Model: Stinger-C1 Fax Option		Date: 15-Jan-00	No.: MA891001
Modified Article: Modular Cord Change		Prepared by: K. Miura	
From: Technical Services Dept., GTS Division			
Reason for Modification:	<input type="checkbox"/> Parts catalog correction <input type="checkbox"/> To facilitate assembly <input checked="" type="checkbox"/> Part standardization	<input type="checkbox"/> Vendor change <input type="checkbox"/> To improve reliability <input type="checkbox"/> Other	<input type="checkbox"/> To meet standards ()

Model: Stinger-C1 Fax Option	Date: 15-Jan-00	No.: MA891002a
------------------------------	-----------------	----------------

Model: Stinger-C1 Fax Option		Date: 15-Feb-00	No.: MA891003
Modified Article: Quick Dial Flap		Prepared by: K. Miura	
From: Technical Services Dept., GTS Division			
Reason for Modification:	<input type="checkbox"/> Parts catalog correction <input type="checkbox"/> To facilitate assembly <input type="checkbox"/> Part standardization	<input type="checkbox"/> Vendor change <input checked="" type="checkbox"/> To improve reliability <input type="checkbox"/> Other	<input type="checkbox"/> To meet standards ()

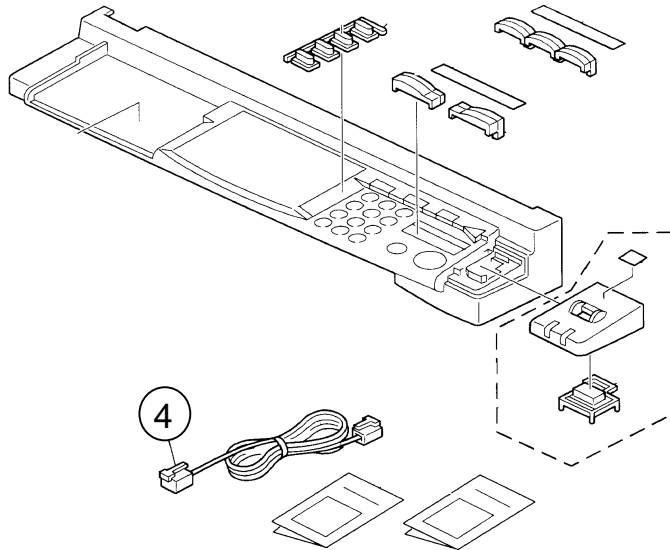
To meet the new standard, the modular cord has been changed.

Old part number	New part number	Description	Q'ty	Int	Page	Index	Note
H0815700	H5235350	Telephone Cable	1	X/O	5	4

Page 3

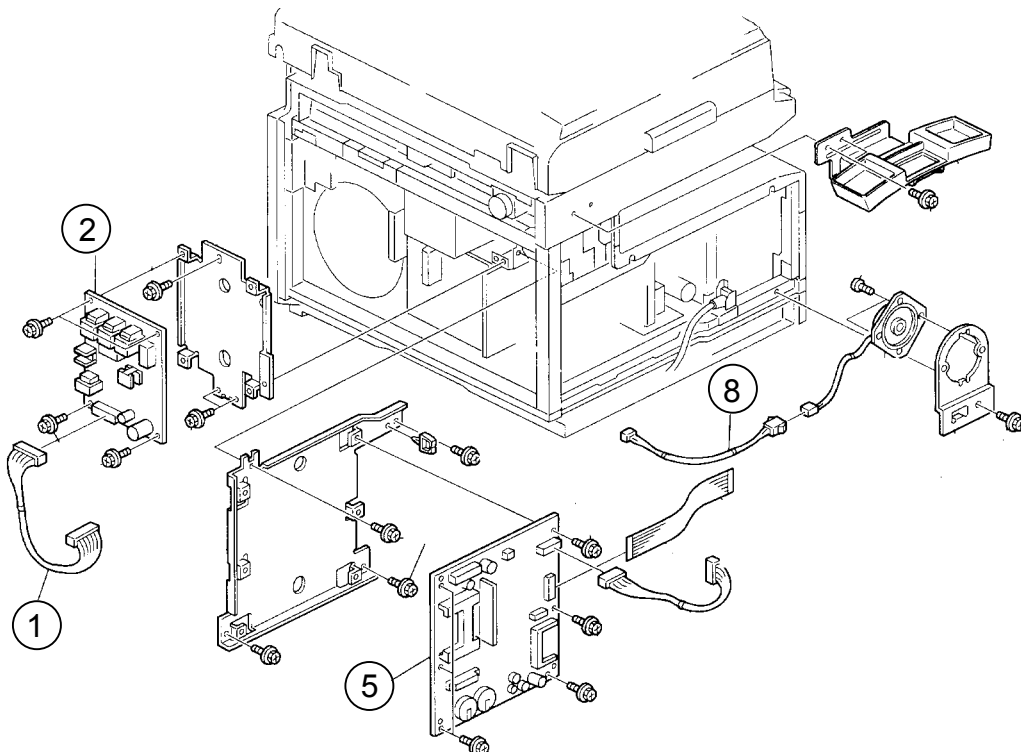
Part Number Change

Old part number	New part number	Description	Index
A2915174		PCB – FCU (ASIA)	5
	A2915166	PCB – FCU (RIC-ASIA/TWN/CHN)	5

Description Change

Part number	Old description	New description	Index
A2915276	Harness – FCU-NCU (EU/ASIA)	Harness – FCU-NCU (Except for NA)	1
54486142	PCB – NCU (EU/ASIA)	PCB – NCU (Except for NA)	2
A2915164	PCB – FCU (EU)	PCB – FCU (EU/OEM-ASIA)	5
A2915273	DC Harness – FCU-MS (EU/ASIA)	DC Harness – FCU-MS (Except for NA)	8

Page 5

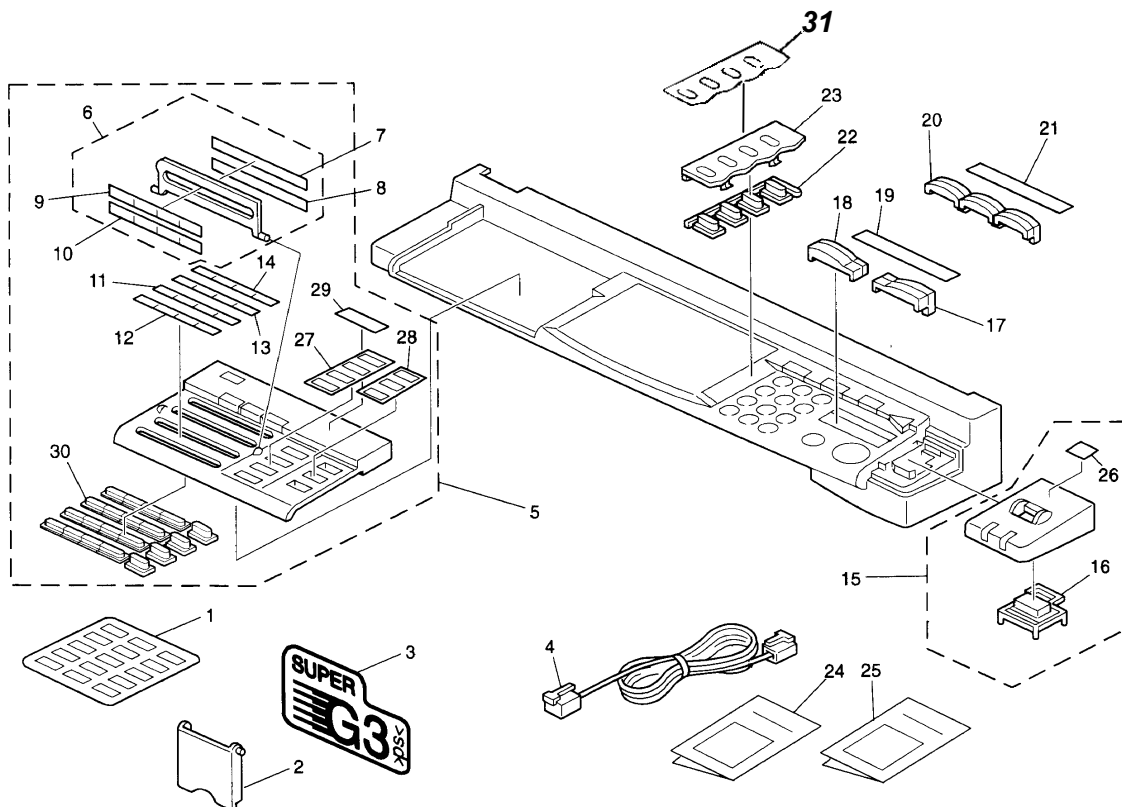
Index No. Change

Part Number	Description	Old Index	New Index
A8911462	Sheet – Cover FAX NA (NA/ASIA)	27	29
A8911464	Sheet Cover Function NA (NA/ASIA)	29	27

Part Number Change

Old part number	New part number	Description	Index
A8911473		Right Cover (EU)	23
	A8911474	Right Cover (EU/TWN/CHN)	23

Description Change

Part number	Old description	New description	Index
A8918467	Fax Operation Panel A'ssy (EU)	Fax Operation Panel A'ssy (EU/TWN/CHN)	*
A8911475	Decal Operation – FAX Option (NA/ASIA only)	Decal Operation – FAX Option (Except for EU)	1
A8918467	Packing FC-KEY2 EU A'SSY (EU)	Packing FC-KEY2 EU A'SSY (EU/TWN/CHN)	5
A8910052	Power Switch A'ssy – A4 (EU)	Power Switch A'ssy – A4 (EU/TWN/CHN)	15
A8911473	Sheet – Power Source Cover A4 (EU)	Sheet – Power Source Cover A4 (EU/TWN/CHN)	26
A2501485	Sheet – Cover Zoom EU (EU)	Sheet – Cover Zoom EU (EU/TWN/CHN)	28

Part Addition

Part number	Description	Index
A8911518	Decal Operation (TWN)	1
A8911508	Decal Operation (CHN)	1
A8911516	Application Decal 2 (TWN)	19
A8911506	Application Decal 2 (CHN)	19
A8911517	Application Decal 3 (TWN)	21
A8911507	Application Decal 3 (CHN)	21
A8918609	Operating Instructions – Taiwanese	24
A8918606	Operating Instructions – Chainese	24
A8918659	CS Manual – Taiwanese	25
A8918656	CS Manual – Chinese	25
A8911502	Sheet – Cover Power Sorce (CHN)	26
A8911514	Sheet – Cover Function (TWN)	27
A8911504	Sheet – Cover Function (CHN)	27
A8911501	Sheet – Cover Zoom (CHN)	28
A8911513	Sheet – Cover FAX (TWN)	29
A8911503	Sheet – Cover FAX (CHN)	29
A8911515	Sheet – Right Cover (TWN)	31
A8911505	Sheet – Right Cover (CHN)	31
H5115007	Stamp	32

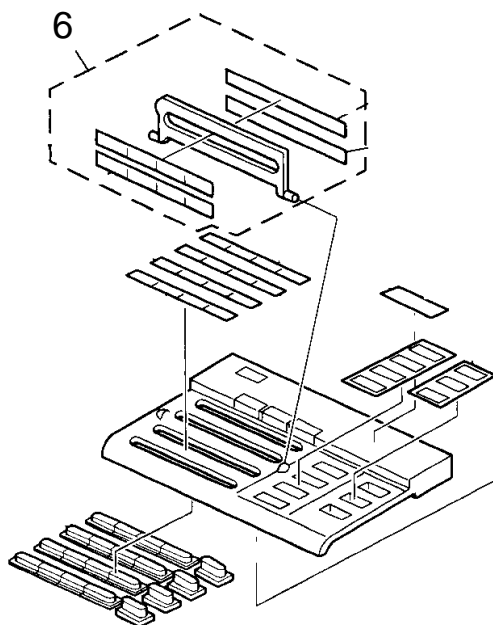
The decals that some customers use for the Quick Dial flap are sometimes thick enough to prevent the flap from pushing down on the detector. As a result, faxes are sent to the wrong destination. To prevent this, the flap itself has been made heavier.

Old part number	New part number	Description	Q'ty	Int	Page	Index	Note
A2509000	A2509001	Plate Onetouch Dial	1	X/O	5	6
